DUKE POWER COMPANY  
OCONEE NUCLEAR STATION  
ATTACHMENT 1a  
IMPROVED TECHNICAL SPECIFICATIONS

This proposed amendment revises the pressure-temperature limits of Improved Technical Specification (ITS) 3.4.1 and Current Technical Specification (CTS) 3.1.2 for Oconee Units 1, 2, and 3. The proposed amendment will revise the heatup, cooldown, and inservice test limitations for the reactor coolant system of each unit. For Units 1, 2, and 3, the current pressure-temperature limits are established to 21, 19, and 21 effective full power years (EFPY), respectively. The service period for the new pressure temperature limits will be to a maximum of 26 EFPY for Units 1, 2 and 3.

Figure 3.4.3-1 (page 1 of 1)  
RCS Normal Operational Heatup Limitations  
Applicable for the First (21) EFPY - Oconee Nuclear Station Unit 1

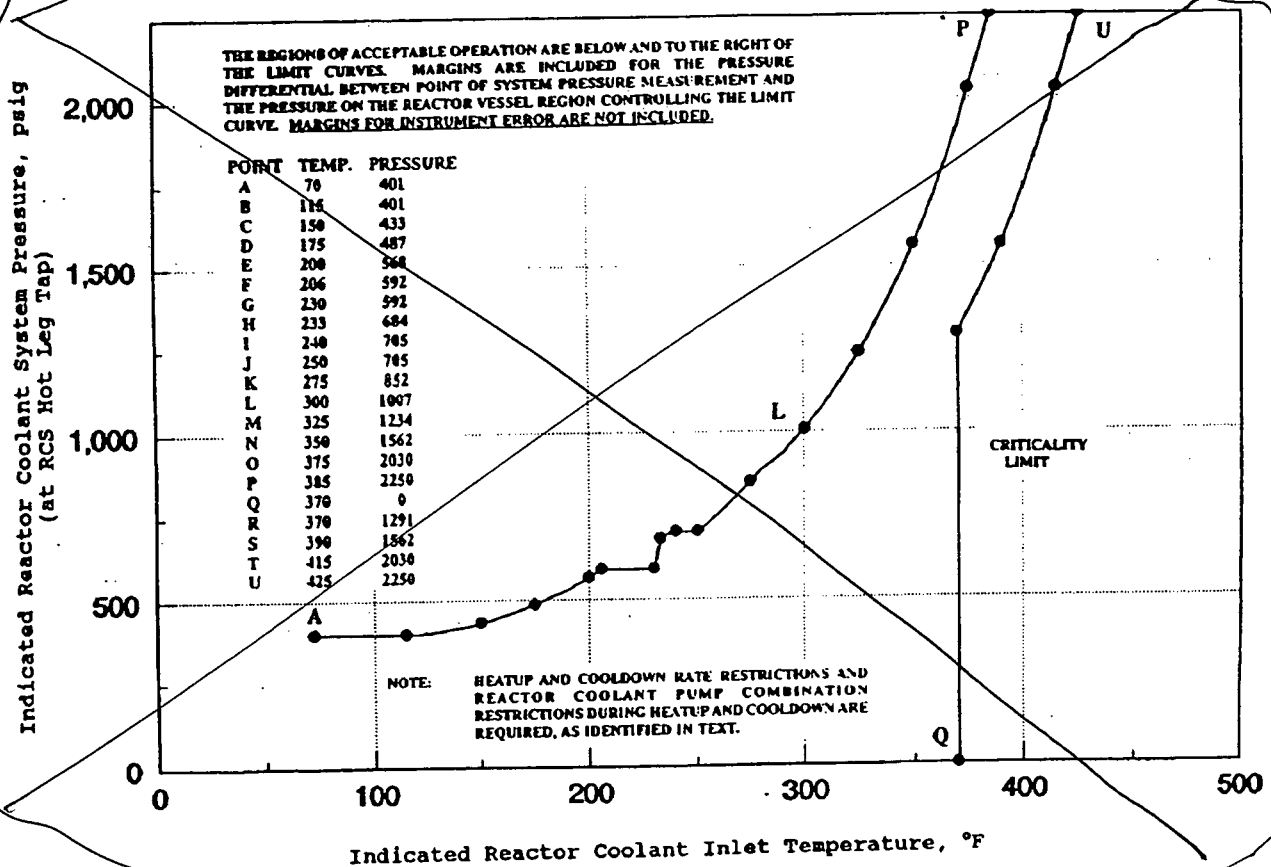
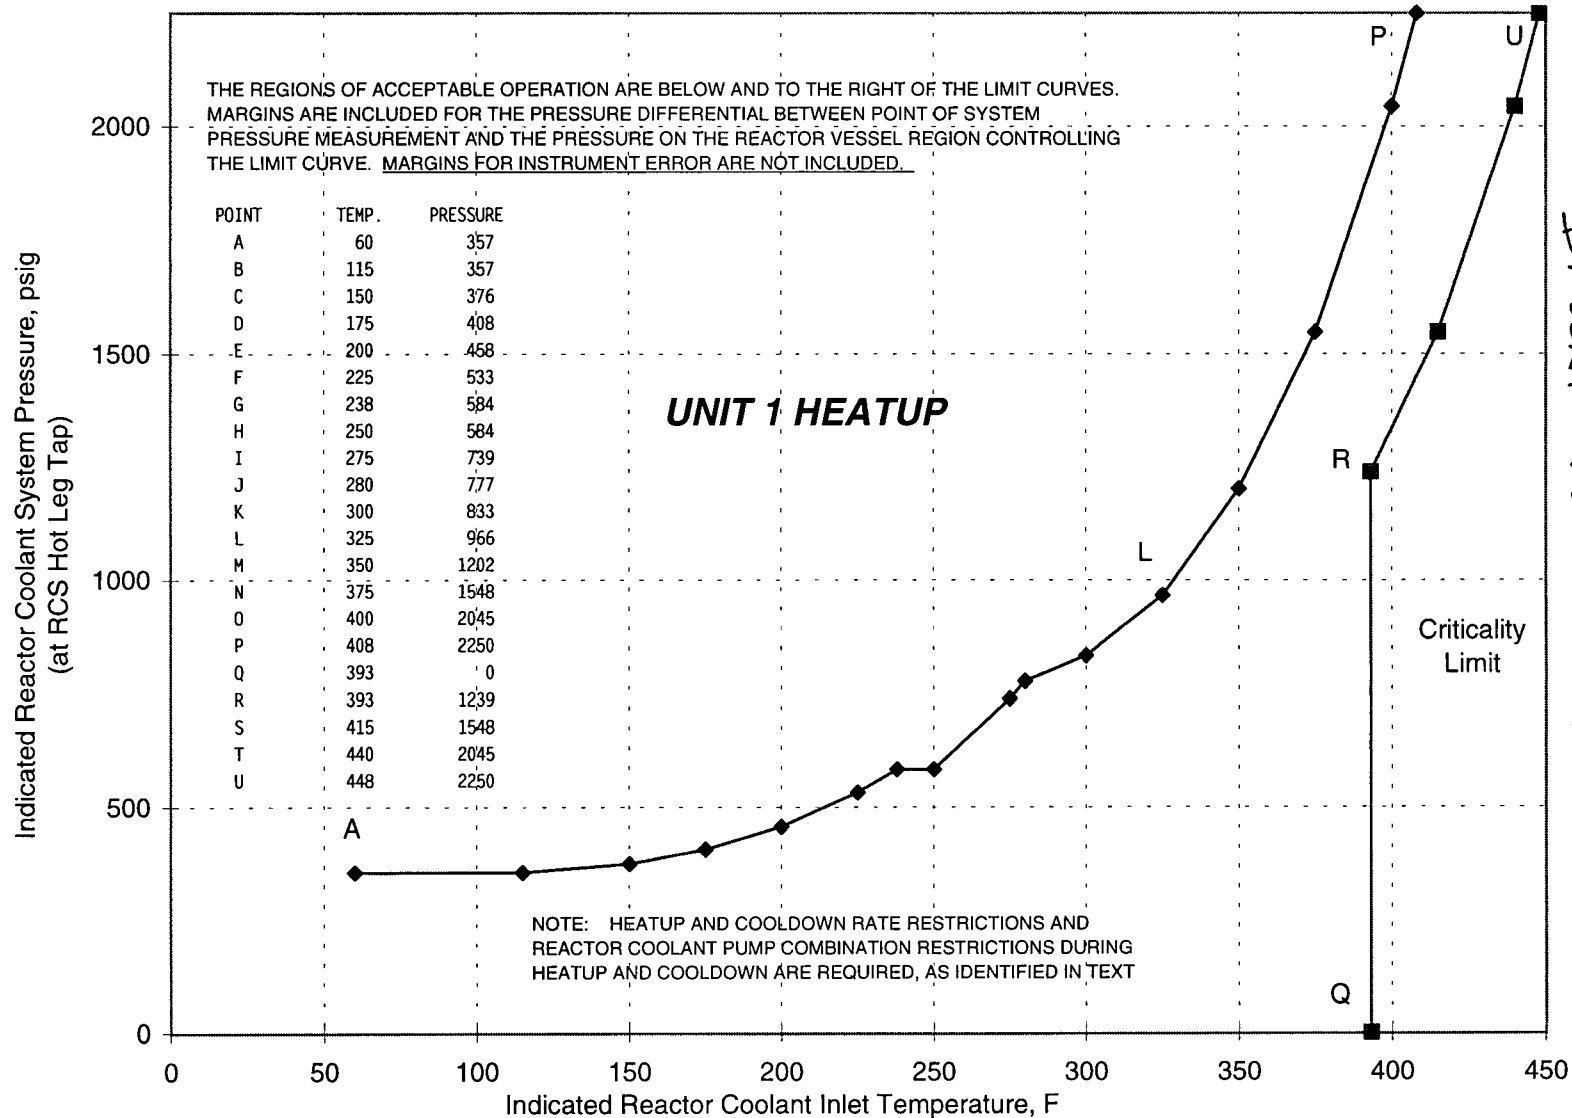
INSERT REVISED FIGURE

INSERT FOR FIGURE 3.4.3-1

Figure 3.4.3-2 (page 1 of 1)  
RCS Normal Operational Cooldown Limitations  
Applicable for the First <sup>(2)</sup> EFY - Oconee Nuclear Station Unit 1

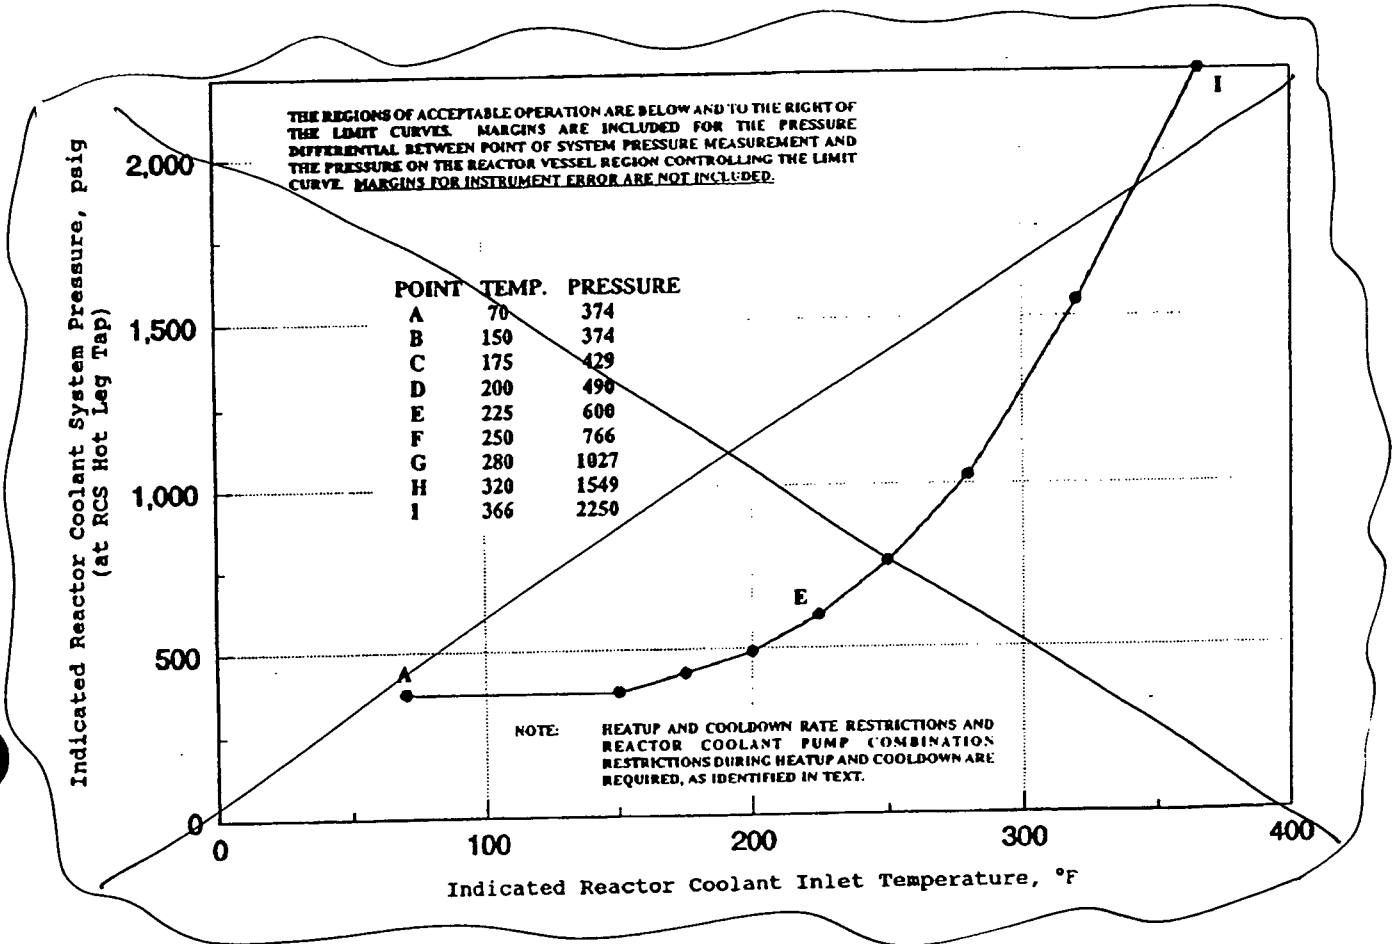
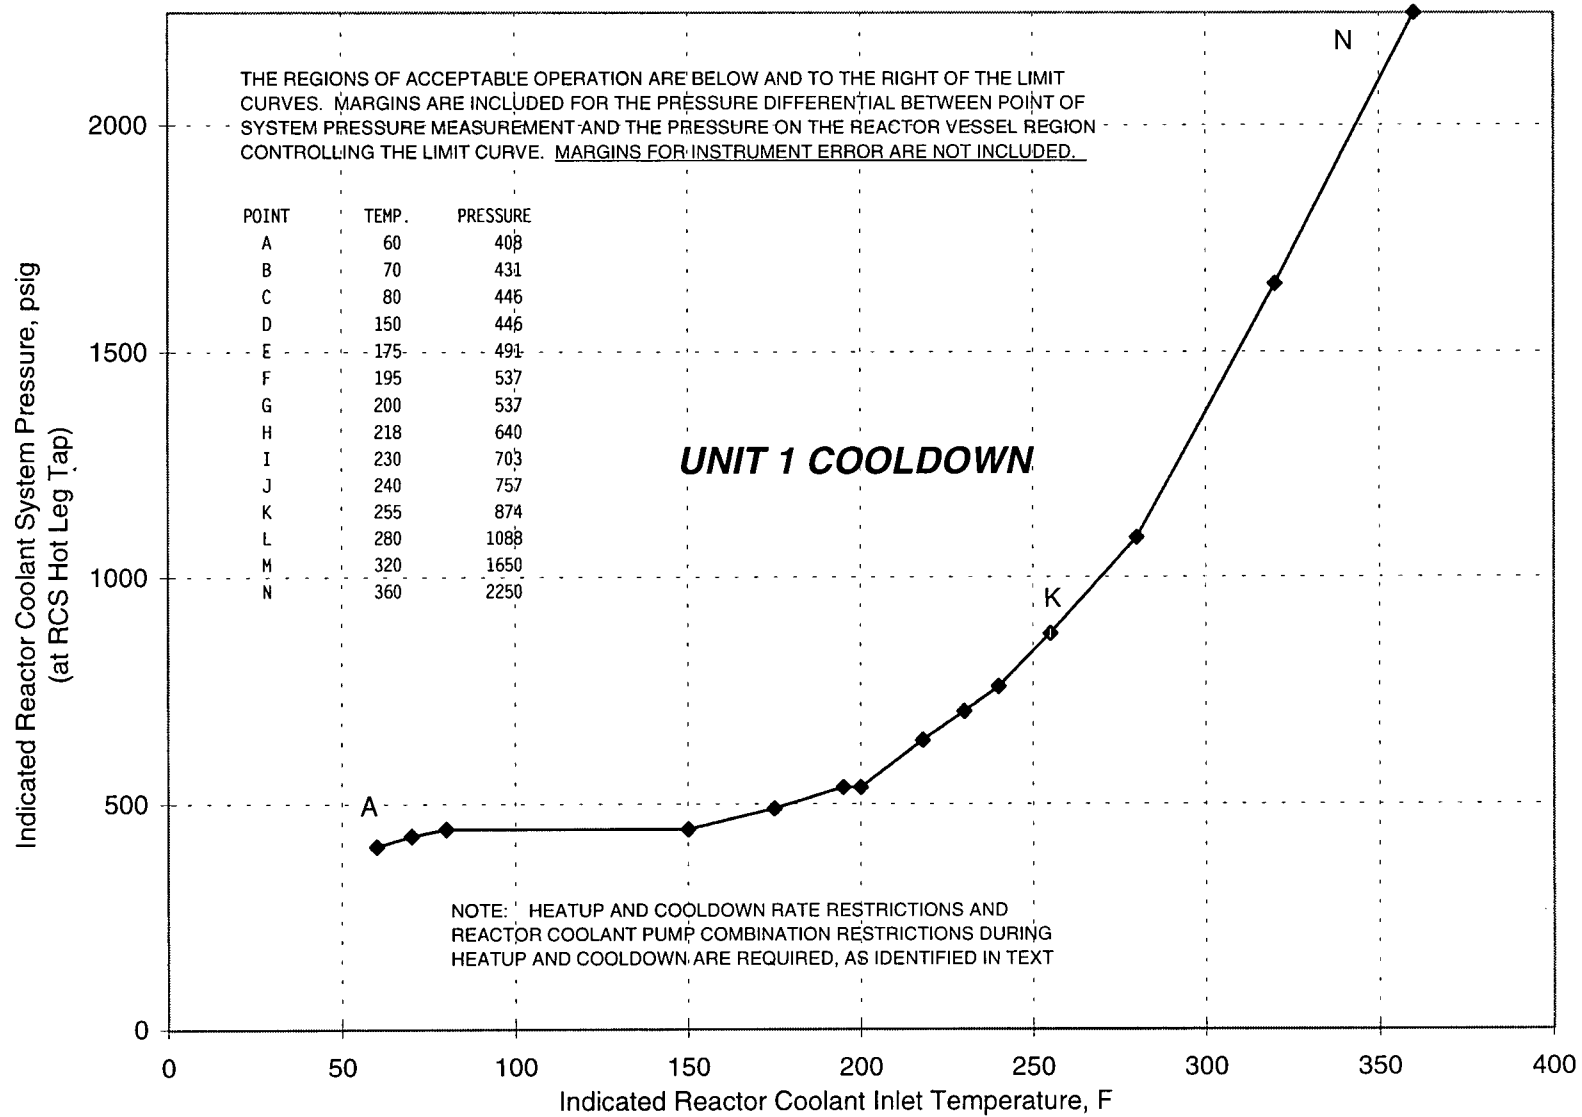
# INSERT - REVISED FIGURE

INSERT FOR FIGURE 3.4.3-2

Figure 3.4.3-3 (page 1 of 1)  
RCS Leak and Hydrostatic Test Heatup and Cooldown Limitations  
Applicable for the First 21 EFY - Oconee Nuclear Station Unit 1

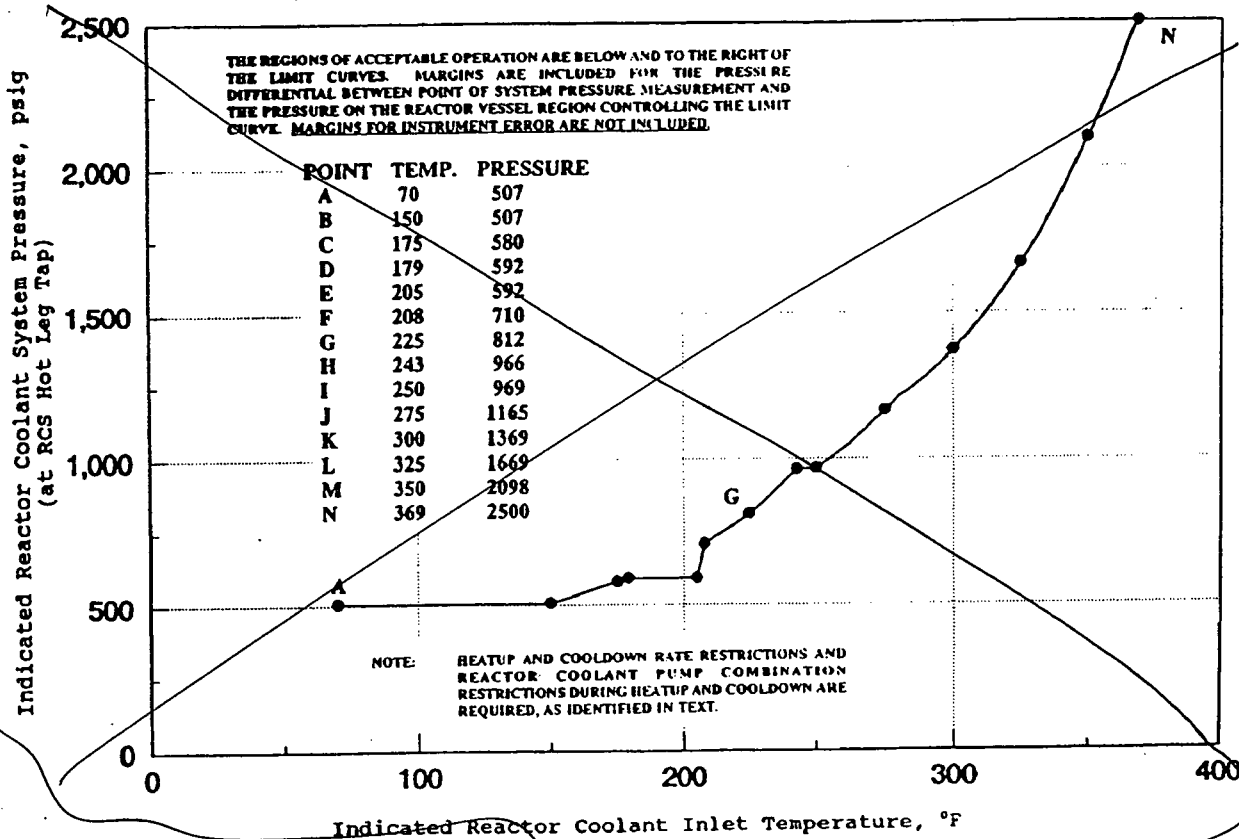
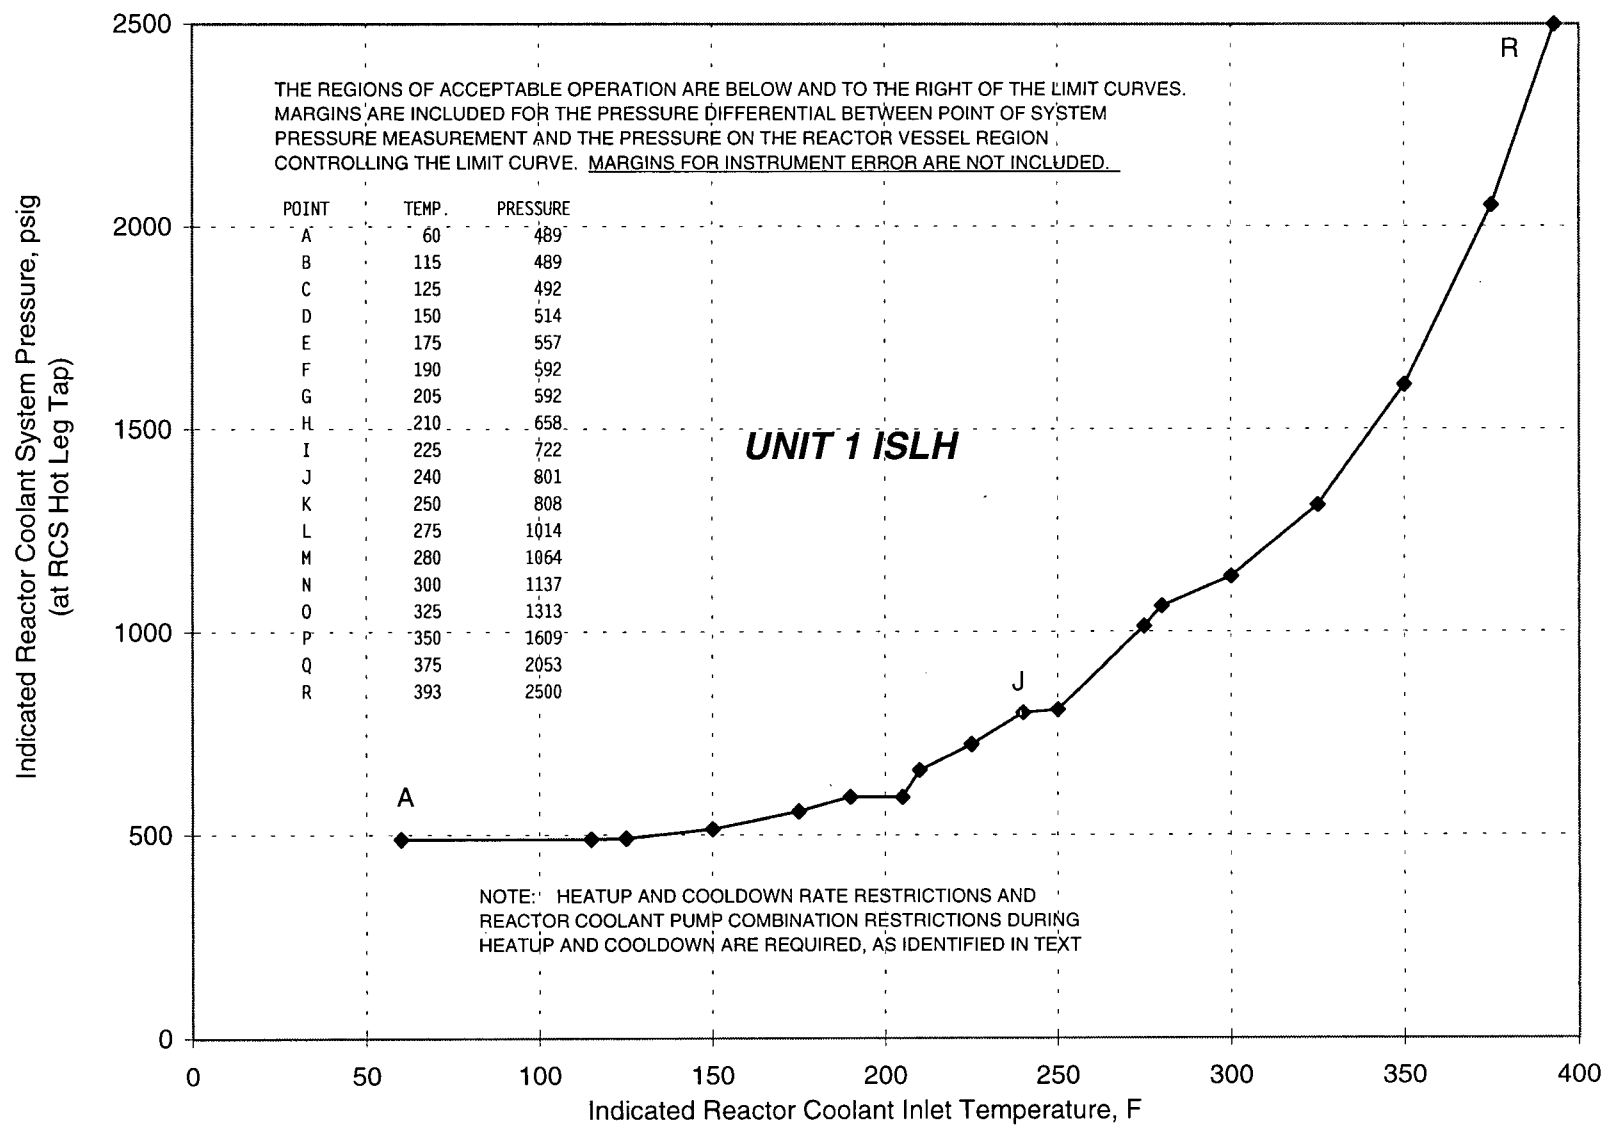
# INSERT REVISED FIGURE

INSERT FOR FIGURE 3.4.3-3
